COMMUNITY ZONING APPEALS BOARD 11

Official Zoning Agenda

MEETING OF WEDNESDAY, JANUARY 7, 2009

Site plan (temp)

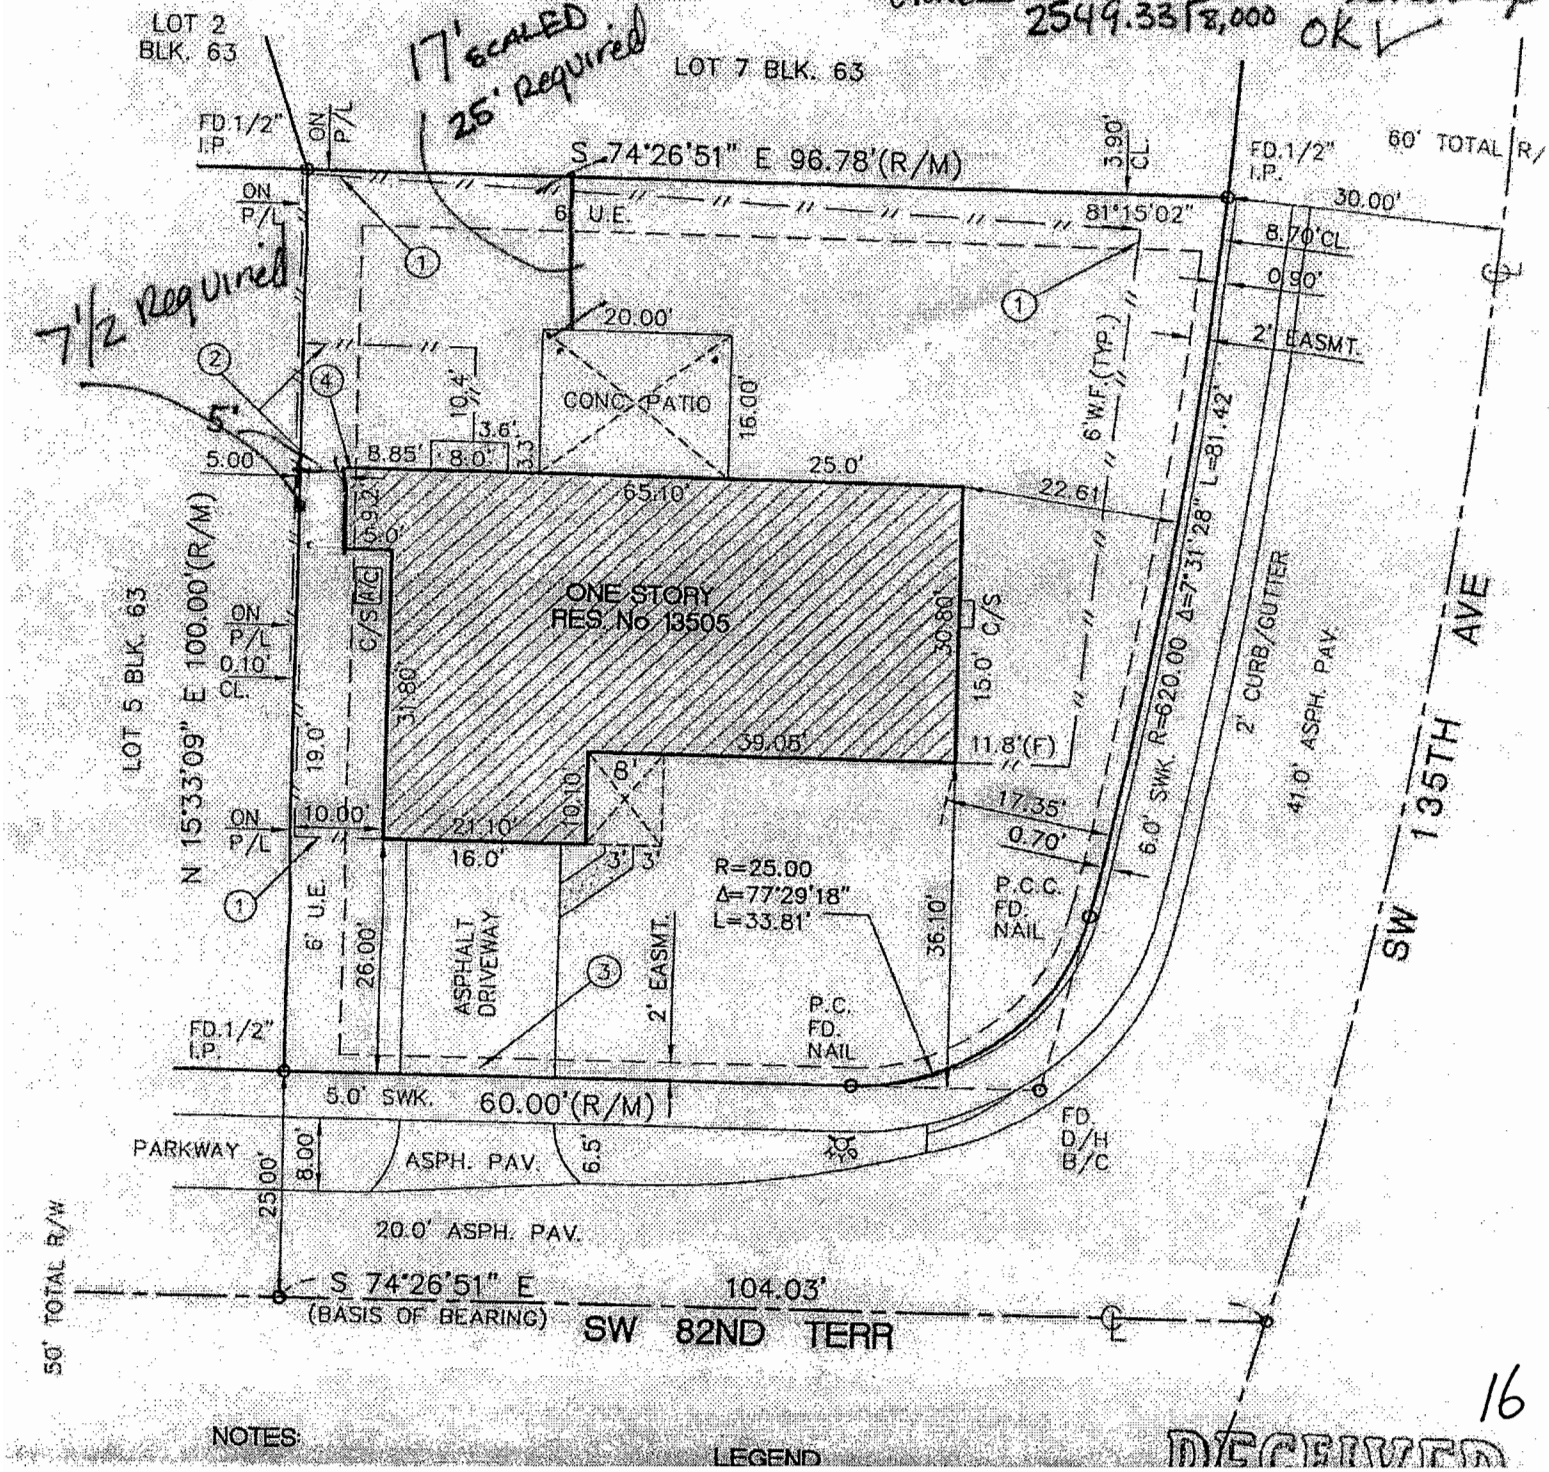
Approval of the application will allow the maintenance and continued use of an existing bathroom addition attached to the northwest portion of the residence located within the required 7.5' interior side (west) setback area. In addition, it will allow the maintenance and

continued use of an existing covered terrace addition attached to the rear portion of the residence located within the required 25' rear (north) setback area. The subject property is designated for **Low Density Residential** use on the Land Use Plan (LUP) map of the Comprehensive Development Master Plan (CDMP), which allows a minimum of 2.5 to a maximum of 6.0 dwelling units per gross acre for a total of 1 unit on this site. Since the requests will not add additional units to the community, the 9,678 sq. ft. RU-1 zoned single-family residential lot is **consistent** with the Low-Density Residential designation as shown in the LUP map of the CDMP.

5. That the covered terrace addition not be enclosed in any manner except for approved insect screen materials.

SITE PLAN
SCALE: 3/16"=1'-0"

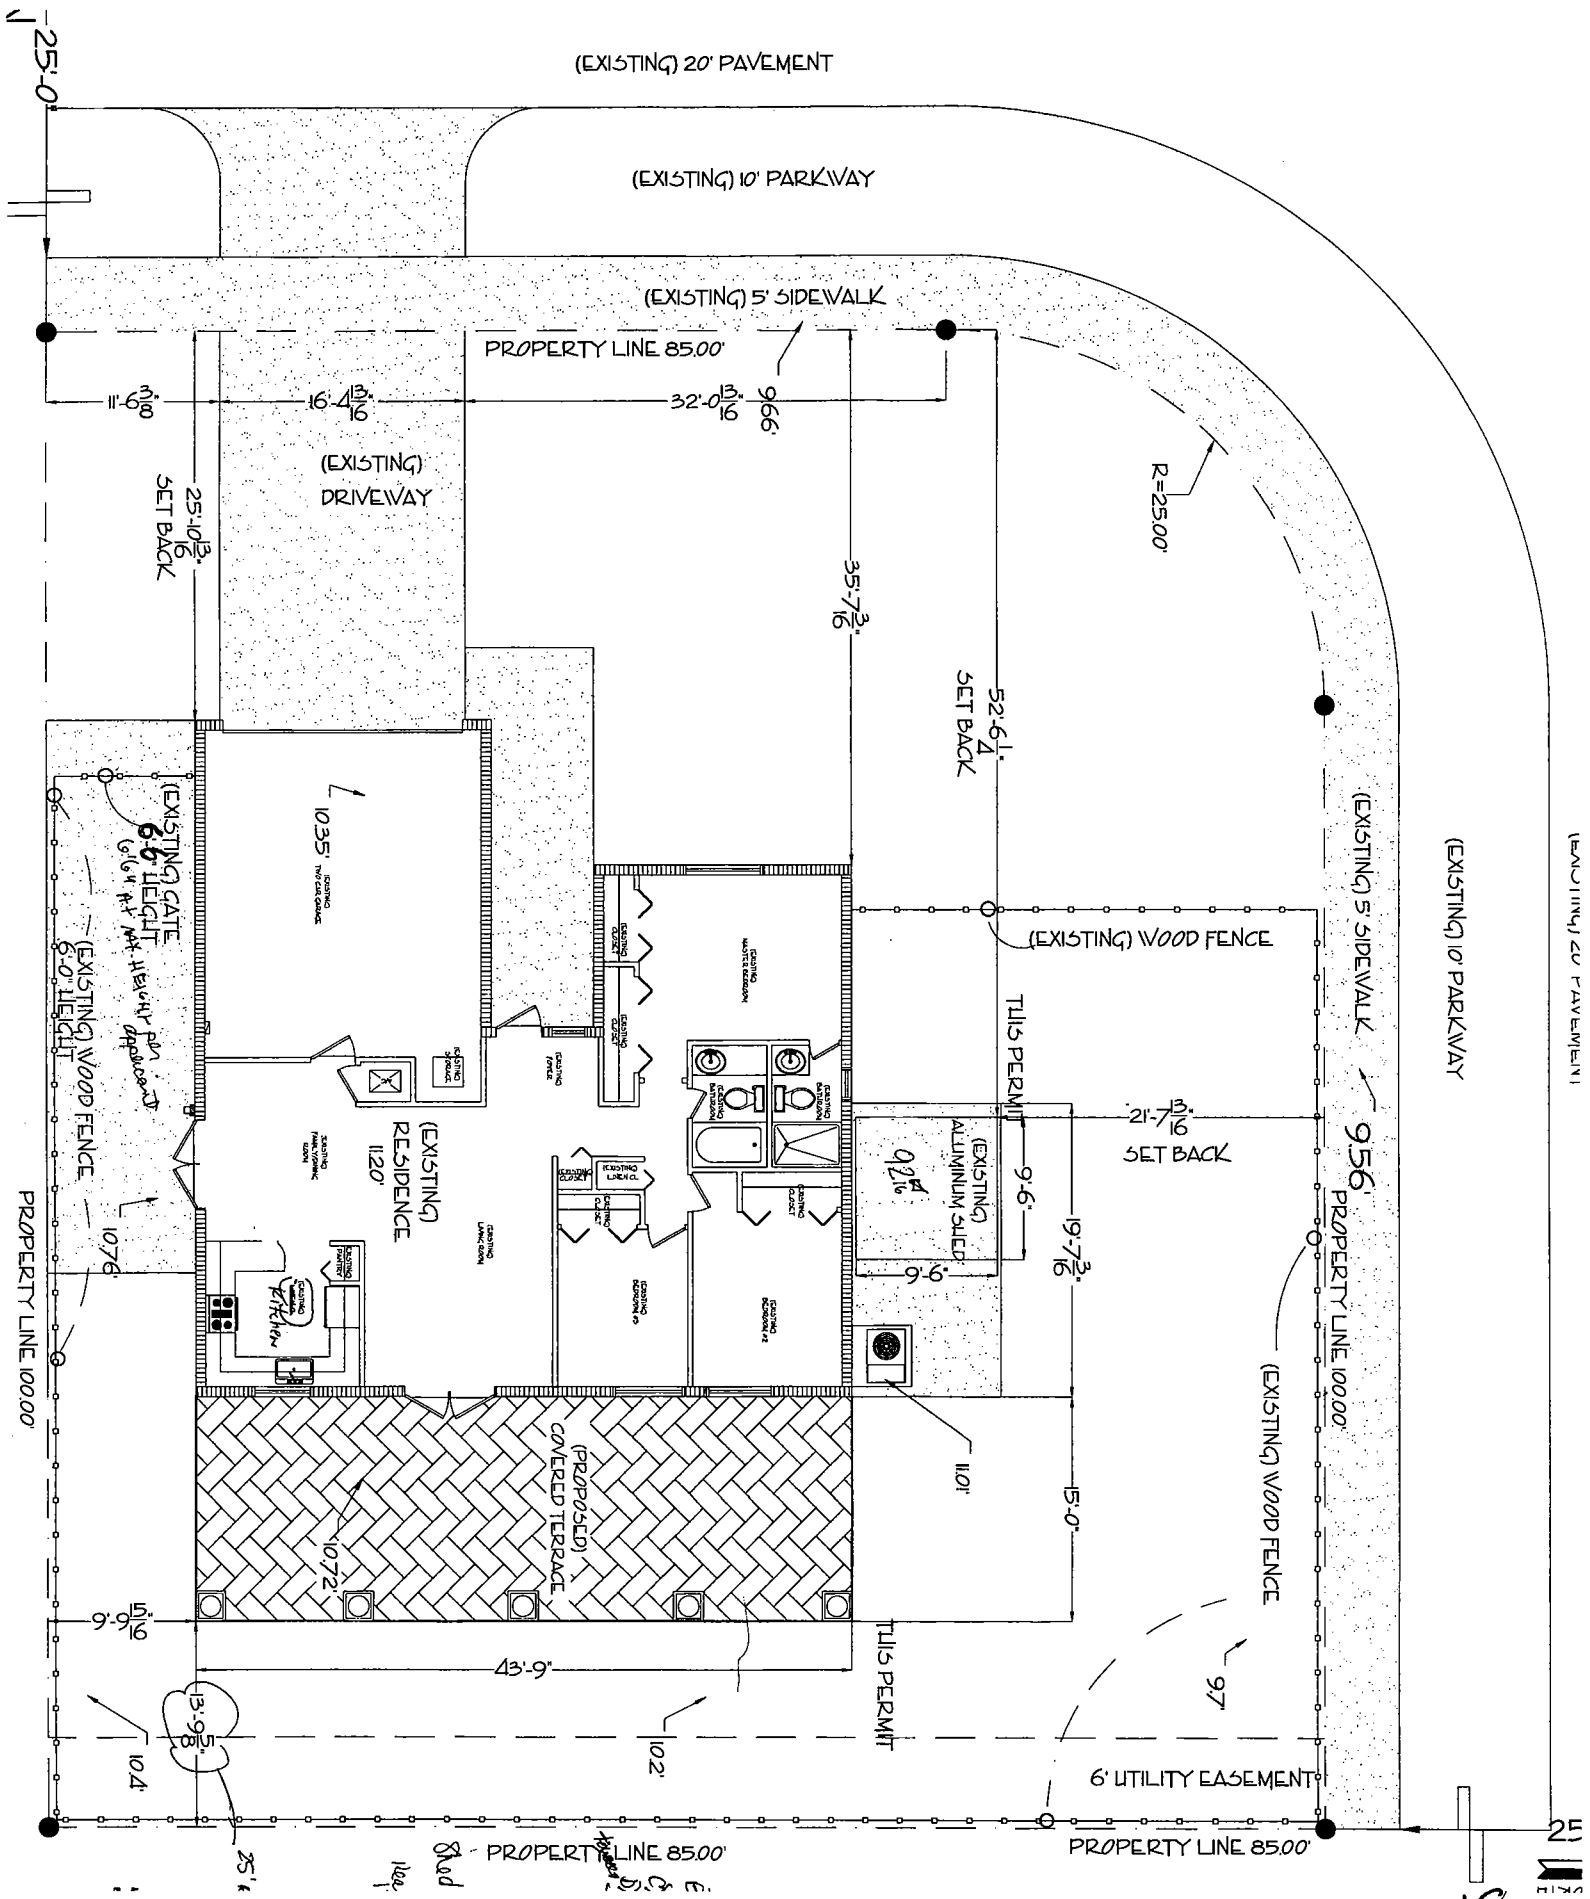
Tree Preservation
According to the site plan submitted with this zoning application, the proposed rear terrace will not impact tree resources. Therefore, DERM has no objection to this zoning application. However, the applicant is advised a Miami-Dade County Tree Removal Permit is required prior to the removal or relocation of any tree that is subject to the Tree Preservation and Protection provisions of Chapter 24
